Re: Champlain Wind, LLC
Bowers Wind Project – DP 4889

Champlain Wind, LLC (“Champlain”) is providing the following response to LURC review comments on the Bowers Wind Project, as well as to comments received from LURC third-party review consultants and other review agencies.

Figures 1 and 2 show the peak timing of discovery of bird and bat fatalities during four mortality studies at wind farms in Maine (Mars Hill 2007 and 2008, Stetson I 2009, and Stetson II 2010).

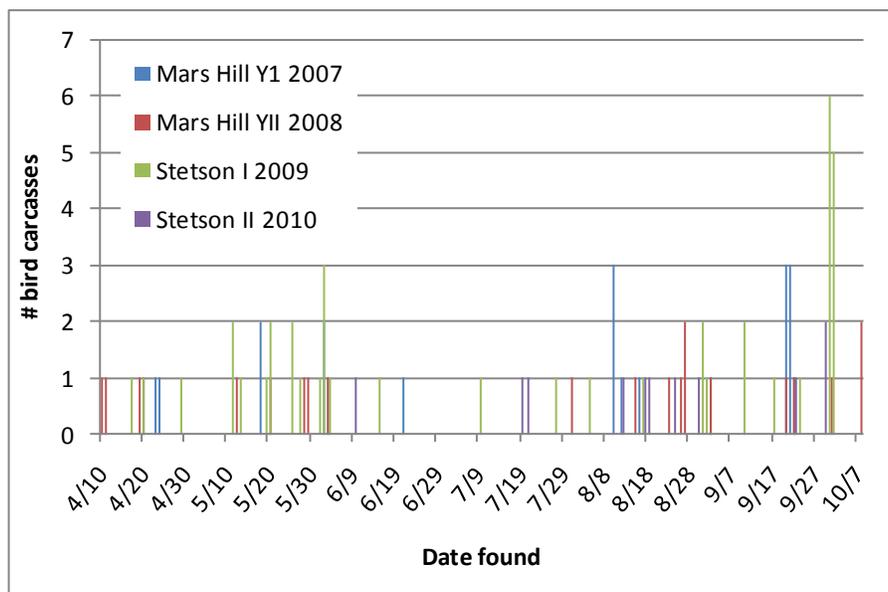
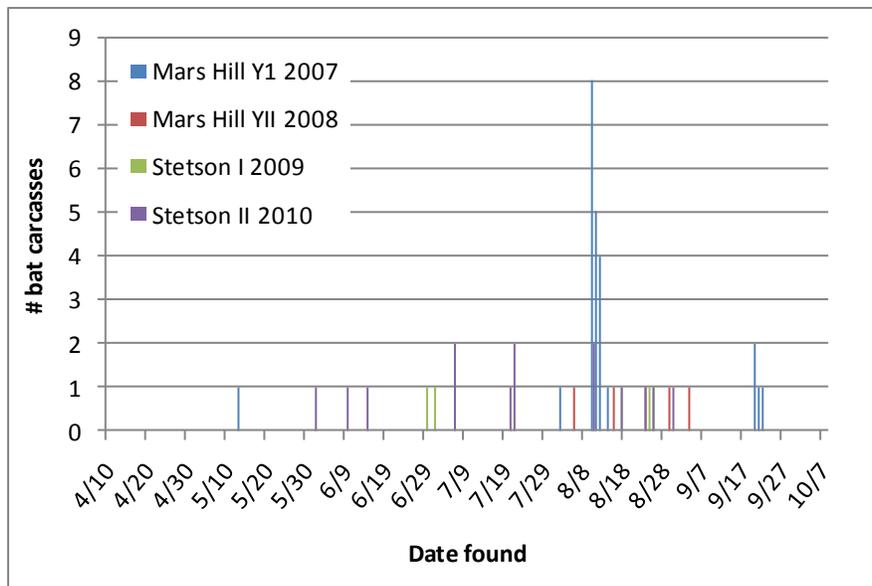
3. **Comment:** “Post-Construction Avian and Bat Fatality Monitoring Protocol: MDIFW will be requesting a minimum of two years of post-construction monitoring with an option for a third depending on results from the previous two years. Exhibit 19 of the Application provides a good starting point however as stated by the Applicant, the final work plan will be developed in consultation with MDIFW if and when the project is approved by LURC. The post-construction monitoring plan must be finalized and approved by MDIFW prior to the approval for the permit. Of note in the Avian and Bat Survey Reports, the proportion of targets flying below the maximum turbine height was quite high during the spring surveys.”

construction surveys conducted elsewhere in Maine and Northeast. Through consultation with MDIFW and USFWS, new knowledge about avian and bat impacts becomes available after each year of study. We have revised Exhibit 19 to include the details that are consistent with the current information and current MDIFW requirements; it is included as Attachment 3. If there are specific gaps, please let us know. Additionally, Champlain intends to continue consultation and incorporate the results of ongoing monitoring efforts once the project is approved by LURC, and will work with MDIFW and USFWS to finalize the post-construction monitoring plan based on any additional available information.
